## SECURING RIMFIRE SET SCREWS AND PROP ADAPTER

HCAA09\*\*TECH01

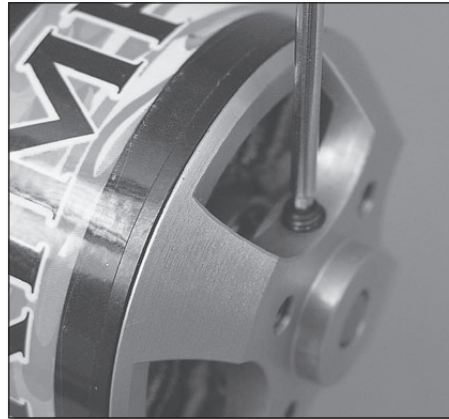
*It has come to our attention that the 3mm set screw and the four 3x10mm cap head screws may not be as tight as needed. Please follow these steps to insure prop security.*

2. Remove the prop adapter by withdrawing the four 3x10mm cap head screws with a 2.5mm hex wrench.

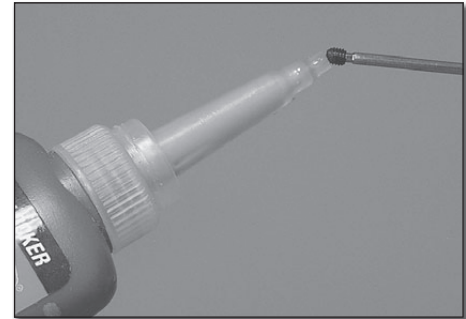
3. Remove the 3mm set screw from the Rimfire with a 1.5mm hex wrench.

4. For best results, add removable thread locker to the threads on the set screw and reinstall. Repeat this process on the 3x10mm cap head screws and reinstall the prop adapter.
